**Draft City of Sydney Submission to the  
Public Exhibition of the Waterloo  
Estate (South) Planning Proposal and  
draft Waterloo Estate (South) Design  
Guide**

# Waterloo Estate (South) Planning Proposal – Submission

Figure 2: City's proposed height in metres map (LEP)

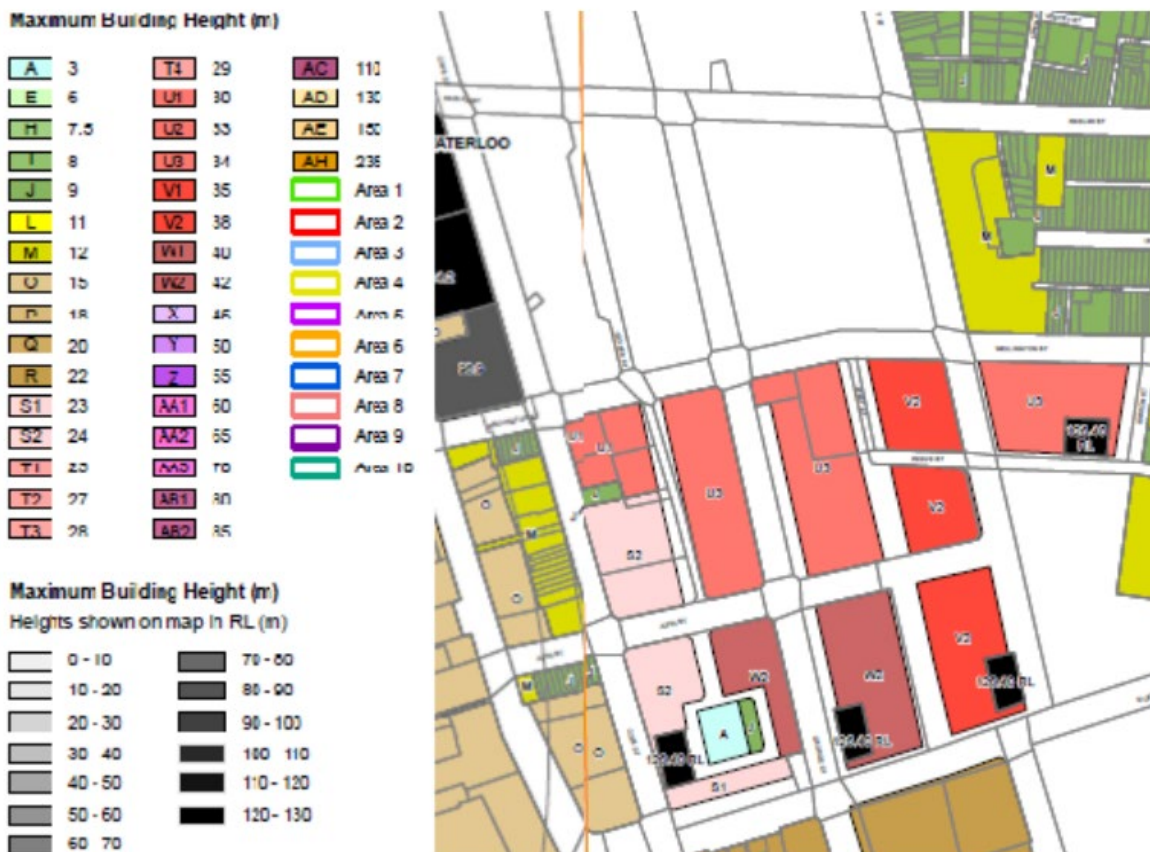
The maximum building heights in the planning proposal (LEP maps) (Figure 2) have significantly changed from what was proposed by the City (Figure 3). The change is prompted by the Gateway determination instruction to modify the height map to “*remove the 3m and/or 6m height control that depicts the location of private internal courtyards and apply the adjacent maximum heights*” and to “*set simplified maximum heights above ground on the Height of Building Map, including an allowance for roof top communal facilities and flood levels*”.

The simplification of the LEP maps allows for a significantly altered building envelope than that shown in the draft design guide and places several of the aims and principles of the planning proposal in jeopardy. Key risks include:

- placing heights on lots containing heritage items well beyond the existing height of the item;
- increased height immediately adjacent to heritage items;
- exposing narrower streets to heights that are in proportion to wider streets or park frontages on the opposite side of the blocks;
- loss of articulation of height in relation to street width and orientation, park frontage, corner emphasis;
- substantial decreases of sun access to streets and parks;
- loss of relationship to areas subject to flooding; and
- loss of relationship to the topography.

- Reconsider and adopt where relevant the reduced building heights along streets shown in the preferred direction of the Addendum Urban Design Review.
- Rework the maximum building height map in the planning proposal to have height zones relating to street widths and park locations.
- Reconcile the height in storeys map in the draft design guide, with the maximum height of buildings map in the planning proposal to ensure they are consistent. This is to provide clarity for the community and future landowners, and also ensure certainty in the development application process.
